Review of Piled Foundation Design—Example of a Fictitious Case

Bengt H. Fellenius, October 2025

Fig. 6 Distributions of axial force and settlement immediately after construction

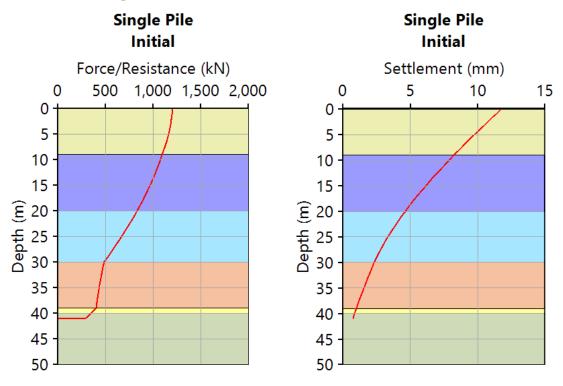
Figure 6 shows the output for the short-term ("initial") distribution of axial force and "settlement" of the pile. The initial conditions are with the initial pore pressures and before the fill was placed, and the "settlement" comprises the pile-toe movement and pile compression as induced by the 1,200-kN sustained load. The first matter worth attention is that the pile compression plus small toe movement for the load placed on a pile during the construction of the structures is about 12 mm. Note, only the settlement developing after the construction is normally of concern for a foundation. A calculation of the long-term deformations and settlement includes this at-end-of-construction value and it needs to be subtracted from the calculated final settlement before assessing what settlement to expect for the structures. Note also that the at-end-of-construction shaft resistance is only mobilized beyond the 5-mm target movement in the upper half length of the pile and that the developed toe resistance is small.

Fig. 7 Load-movement curves from simulation of long-term condition

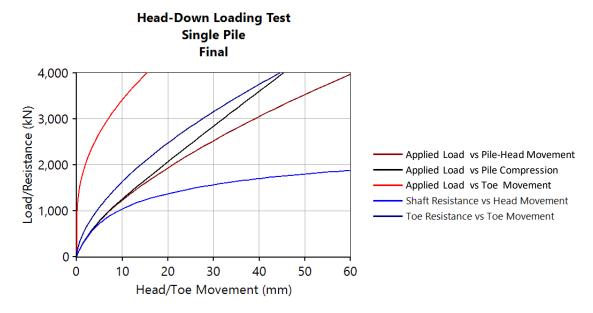
Conventionally, the simulation of the load-movement curves of a static loading test is the first-to-consider output of a piled foundation calculation. Figure 7 shows the UniPile6 output for the long-term ("final") conditions. Looking at a relation between the 1,300-kN total load (sustained plus live load) applied to the pile in relation to a "capacity" determined from the pile-head load-movement curve serves little purpose. The first matter worth attention is that the pile compression for the load is about 12 mm, i.e., half of the stated settlement limit, confirming the observation and conclusion made in regard to Figure 6.

Fig. 8 UniPile6 output for Unified Method

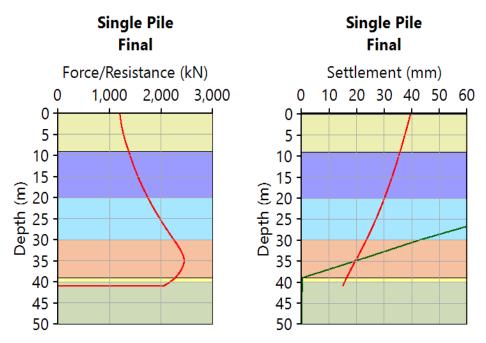
The decisive output for assessing the pile is the settlement and pile force simulation according to the Unified Method shown in Figure 8 (the output also comprises tables). The simulation indicates that the total pile-head settlement is 40 mm. Subtracting the about 10 mm settlement that will have occurred as the structures were built, the analysis suggests that the long-term settlement of the piled foundation will be about 30 mm. The output also shows the Equilibrium Plane at 35 m depth, a maximum force in the pile of 2,700 kN, which is insignificant in relation to the pile structural strength, and a drag force of 1,500 kN, which is of no consequence for the design.

The about 30-mm long-term settlement is a bit larger than the stated "one-inch" limit, 25 mm, but might be accepted as "close enough". However, all analysis input is with a margin and the output has a corresponding margin. The results imply that the design is OK, but they cannot be used to emphatically state that the proposed design is fully satisfactory. Nor can one state that the design will have to be changed. However the analysis results show clearly that the issue is not the reliability, representativeness, or precision of the settlement analysis of the soil, notably the clay, or the assumed β -coefficients, but that of the pile-toe response. For example, a renewed UniPile6 analysis with an N_t -coefficient of 50, i.e., assuming an larger target toe resistance, would lower the depth to the EP and reduce the calculated long-term settlement of the pile.

The best advice would be to look a bit more into the pile toe response. For example, doing dynamic tests (PDA and CAPWAP) on a few of the first construction piles driven as test piles to study the pile toe response, specifically, in terms of bearing and tendency to toe damage
